DATA SYSTEMS DIVISION

technical notes

technical notes
Index

SUBJECT: Revision of Sorcerer II boards and   the   Display Disk
System and Floppy Disk Subsystems.

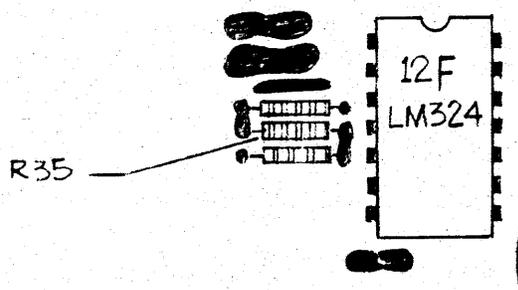
1.   Remove   R35   resistor and replace with a 1/4 watt
1%   270K   OHM   resistor. R35's   location   is
illustrated below in figure.

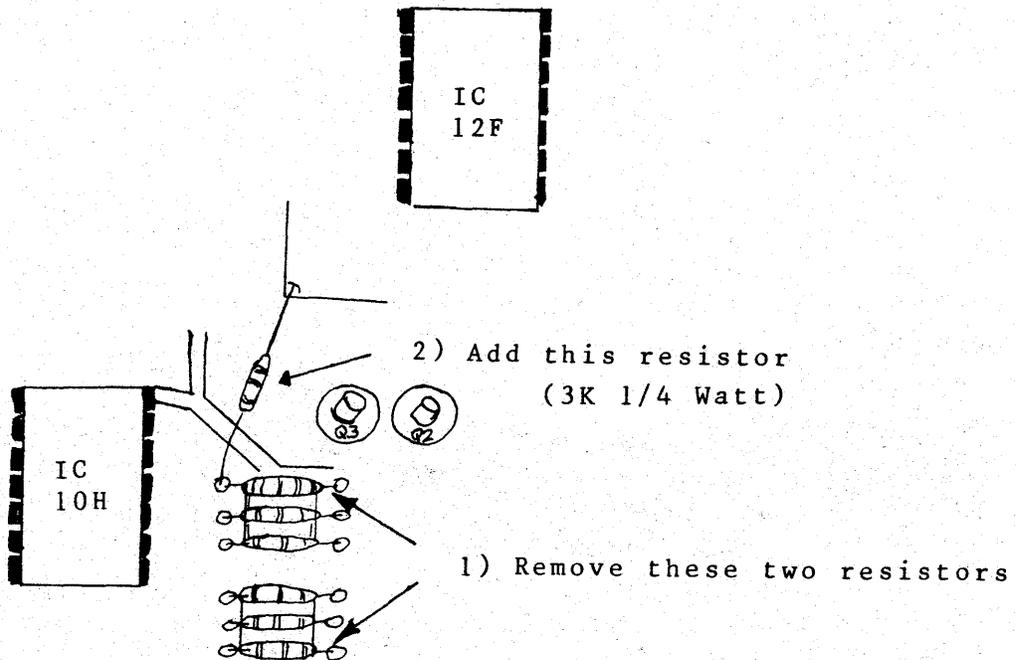
5.   Make video mod changes as indicated in the
     drawing below, by taking out the two resistors
     near IC 10H and adding another one:

2) Add this resistor
   (3K 1/4 Watt)

1) Remove these two resistors

Figure 1: Sorcerer II

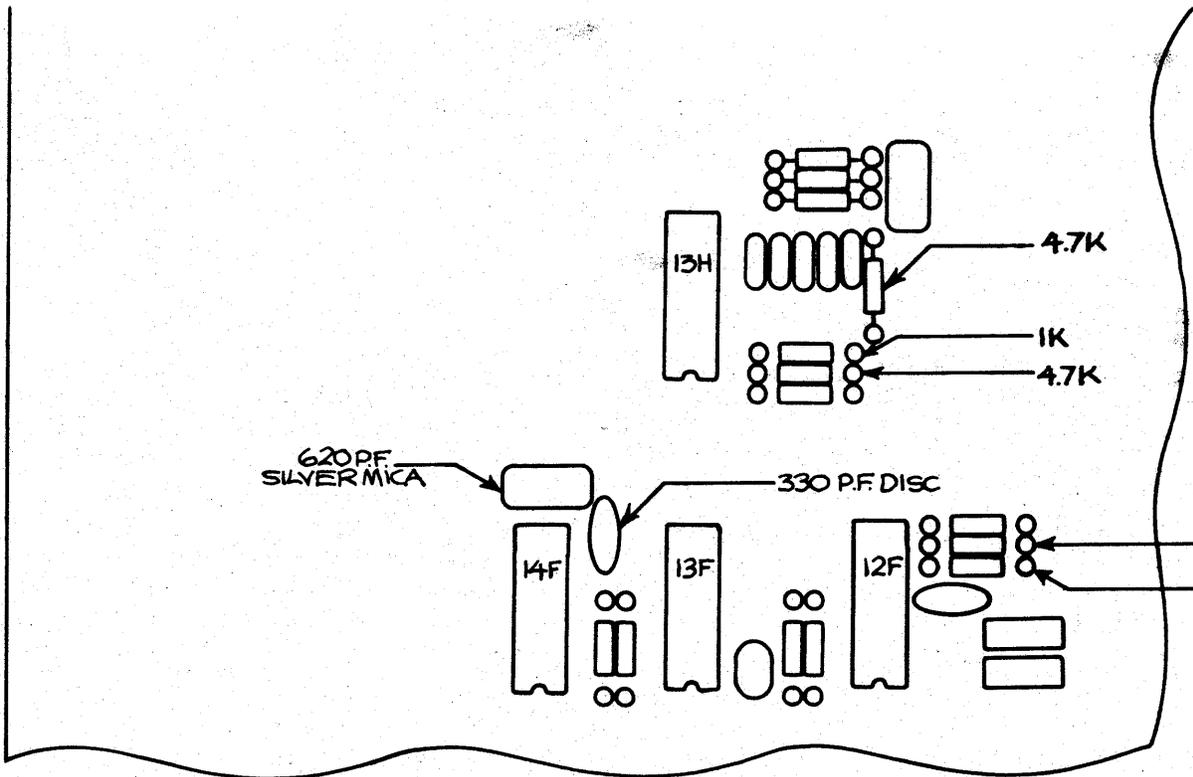
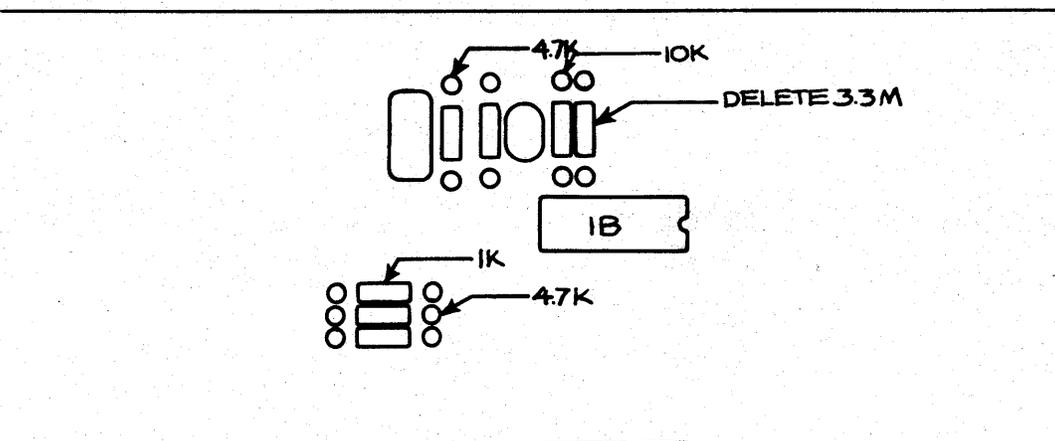
II. Interface changes required:

Receiver:			Sorcerer I	Sorcerer II
13K	to	4.7K	R4	R62
270K	to	10K	R6	R35
1000 pf	to	620 pf silver mica	C16	C67
1000 pf	to	330 pf disc ceramic	C18	C66
3.3 meg	to	REMOVE	R5	R34
